**From:** Fowler, Samuel W. <sfowler@nacintl.com>  
**Sent:** Monday, December 04, 2017 9:30 AM  
**To:** White, Bernard  
**Cc:** Carver, George; Chapman, Deborah R.; Baldner, Heath M.  
**Subject:** [External\_Sender] MAGT Shielding Tolerance

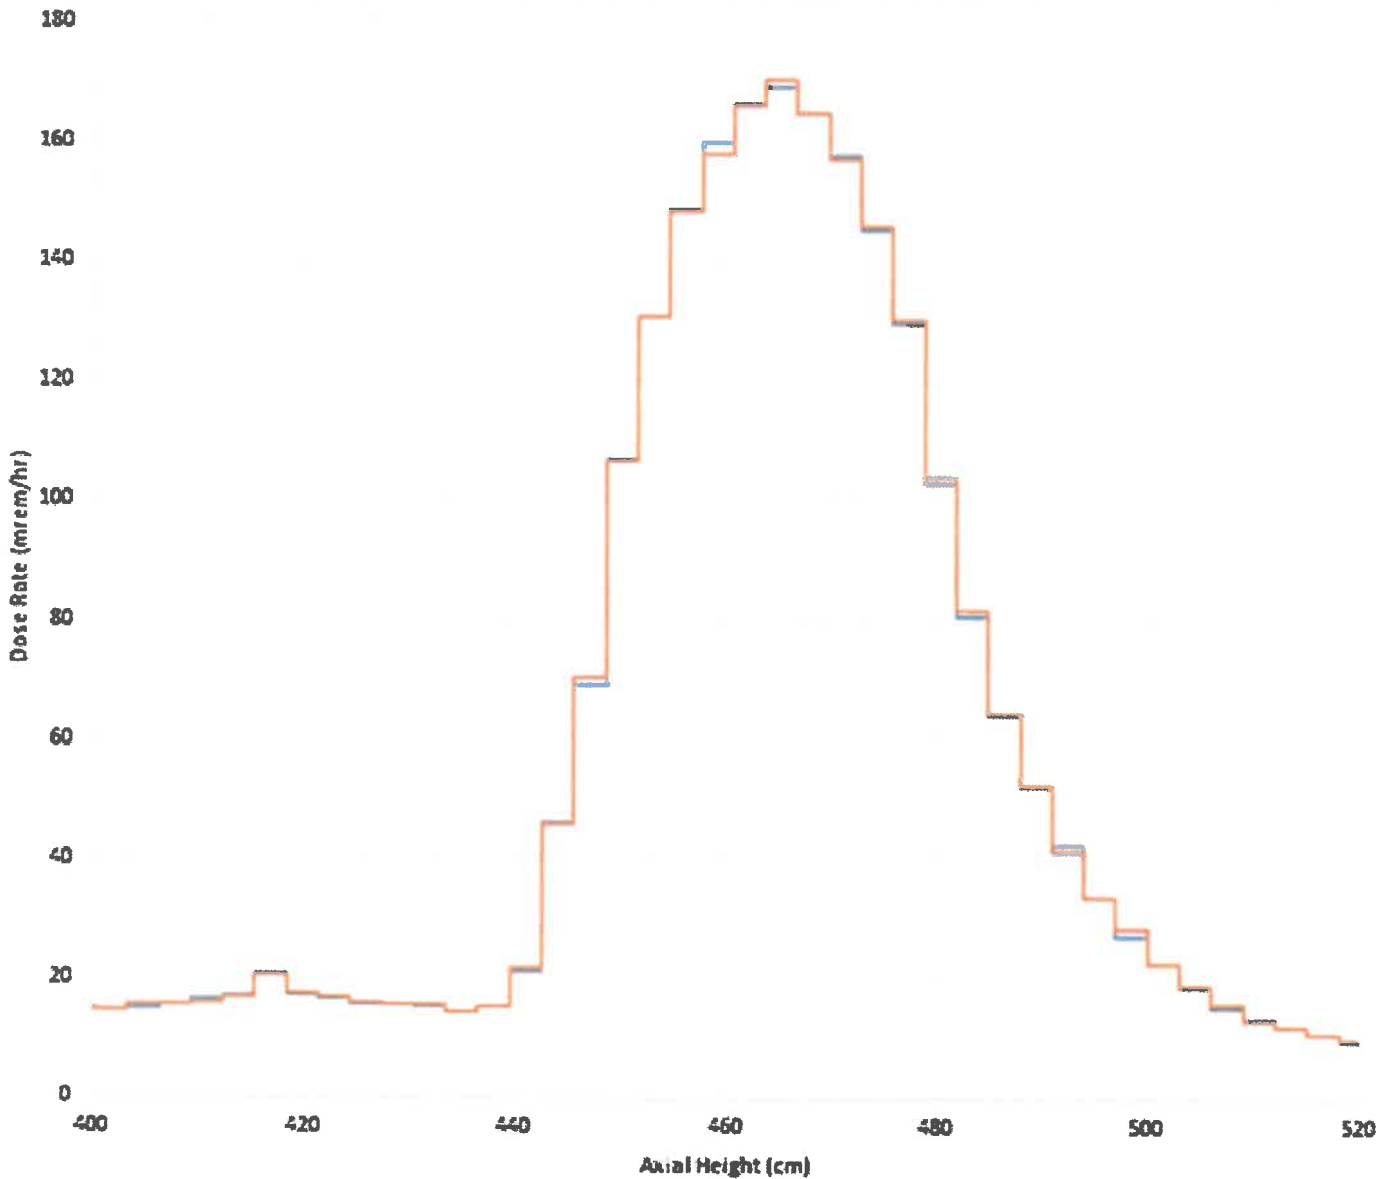
We reran the shielding evaluation with the lead being 0.06-0.09 inches lower (i.e., further from the lid). Below is the surface plot. As you can see, it resulted in a minor shift in the dose rate curve but negligible impact on total dose rate.
